MEMORANDUM

From:	Catherine Brimble Senior Landscape Officer		
Service	SDL Landscape and Trees	App No:	243124
Address:	Land At Bridge Farm, Bridge Farm Lane, Twyford, Berkshire.		
Proposal:	Application for the approval of reserved matters pursuant to outline planning consent 212720 for the erection of 200 dwellings with associated infrastructure, open space, biodiversity enhancements, landscaping and green infrastructure (Appearance, Landscaping, Layout and Scale to be considered).		
Type of Development:	Major Dwellings (10+)		
Site Visit Made:	Yes/No

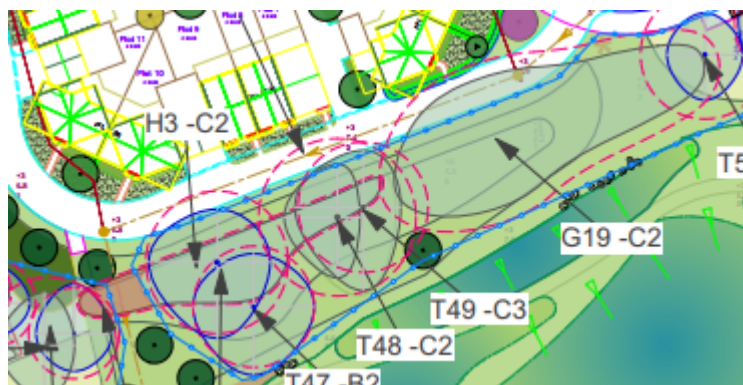
An Overall Levels Strategy drawing (703-SK-03 Rev A) is provided showing existing and proposed levels and the approximate batter down to existing ground levels, which is delineated on the drawing by green embankment markings. This is helpful to see, however the revised levels will need to be fully considered in relation to the arboricultural information as required in section 6.12 of the AIA. I presume that the Arboricultural Consultant has not seen this levels drawing and further revisions will need to be made regarding levels so as not to harm the existing trees to be retained.

There are two areas of concern relating to the change in ground levels and retention of existing trees. The first is on the land opposite plots 5 – 10 as shown in the extract below where there will be ground level changes in the RPA's of retained trees – see second extract.
